STAFF REPORT

CITY COUNCIL
DATE: 5/16/23

AGENDA ITEM: Public Hearing- Drake Motor Partners for Final Plat/Planned Unit Development

PRELIMINARY PLAT

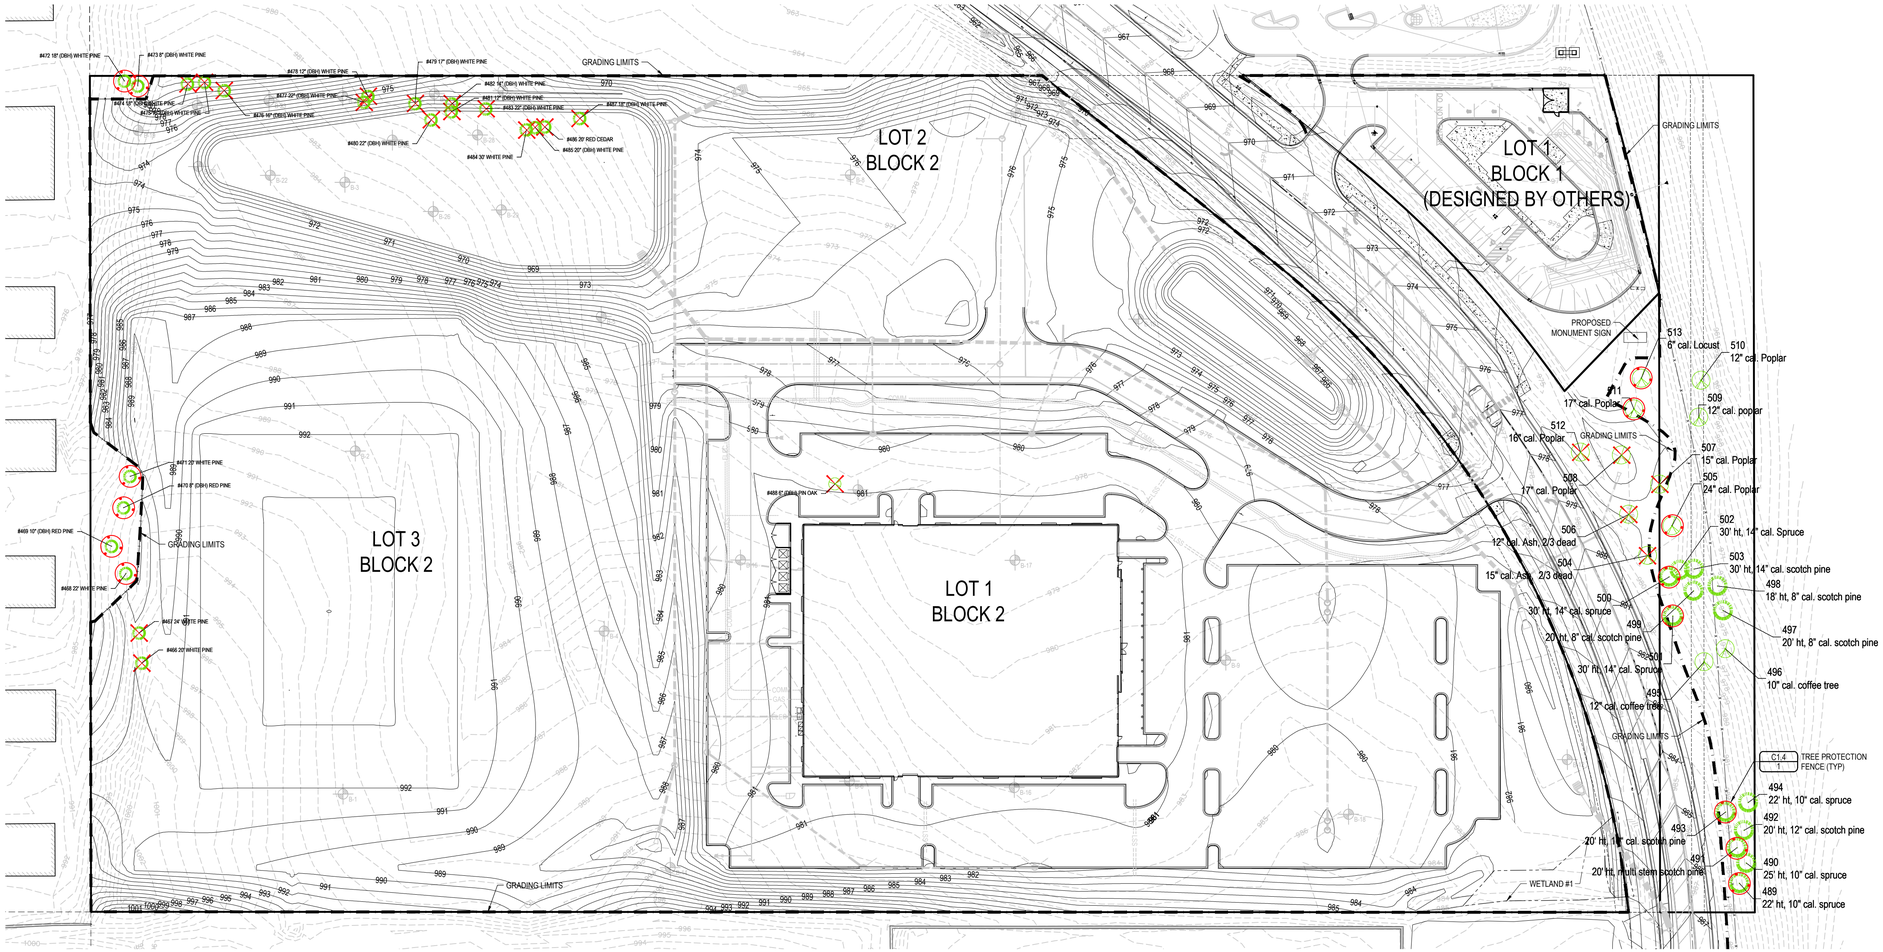
4. Final Plat approval must be contingent upon the dedication of Hudson Boulevard right-of-way as shown on the Preliminary Plat, Sheet C1.2, dated May 2, 2023 and the Final Plat received May 2, 2023; including Outlot A to be deeded to the City of Lake Elmo following the recording of the Final Plat.

5. Outlot A is proposed as part of the Final Plat over the MnDOT trunk highway easement area (Highway Easement Document No. 90695). Final Plat approval must be contingent upon the developer providing to the city all necessary legal descriptions and easement exhibits for the city's application to MnDOT to turnback the area of highway easement over Hudson Boulevard as shown on the Preliminary Plat, Sheet C1.2, dated May 2, 2023.
